009/1.4/WWL.001
RS-NMS-85-009
Communication No. 45

Re: NNWSI Conceptual Model Evaluation Report - Subtask 1.4

Re: Subtask 1.4, Conceptual Model Evaluation
Letter Report for Contract NRC-02-85-009 (WWL #4001)
Technical Assistance in Hydrogeology - Project B - Analysis

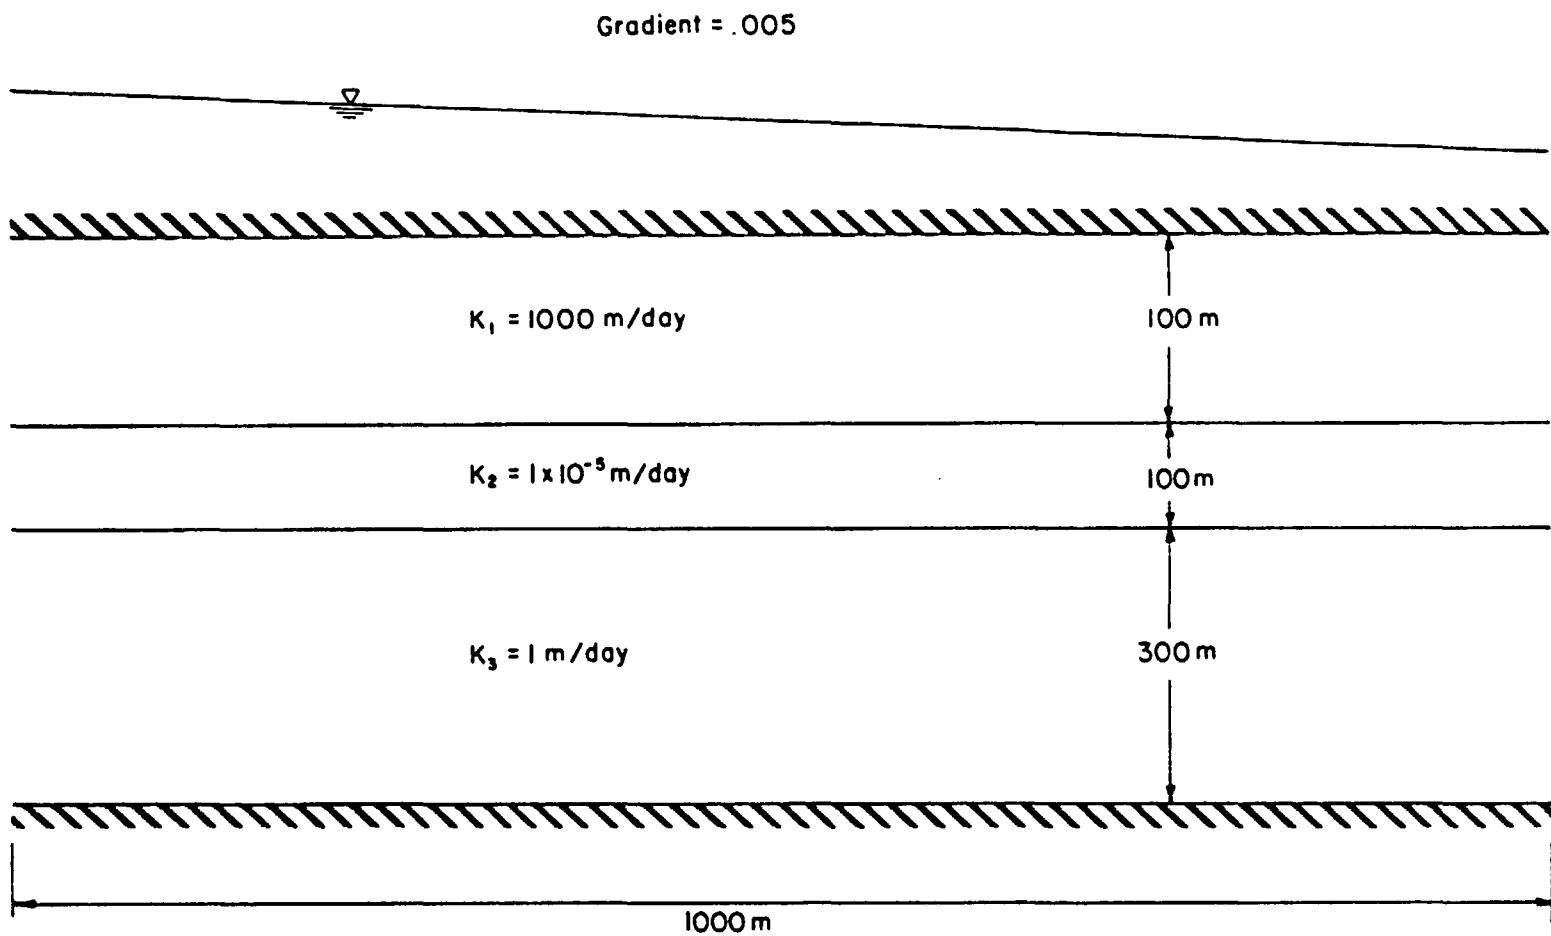
As an example of the effects of the parameter lumping procedures, consider the very simple flow system depicted on Figure 11. While the system at Yucca Mountain is drastically more complex, this simple system will be used to

Using the parameter values presented on Figure 11, a mean K of 200.6 m/d is obtained. Assuming for convenience a uniform effective porosity, n , of 0.10 allows the seepage velocities to be calculated:

As the above calculations demonstrate, the averaging process would provide a travel time of 100 days while contaminants would actually begin to be discharged from the upper layer in about 20 days. As stated previously, the example is substantially less complex than the actual system which exists at
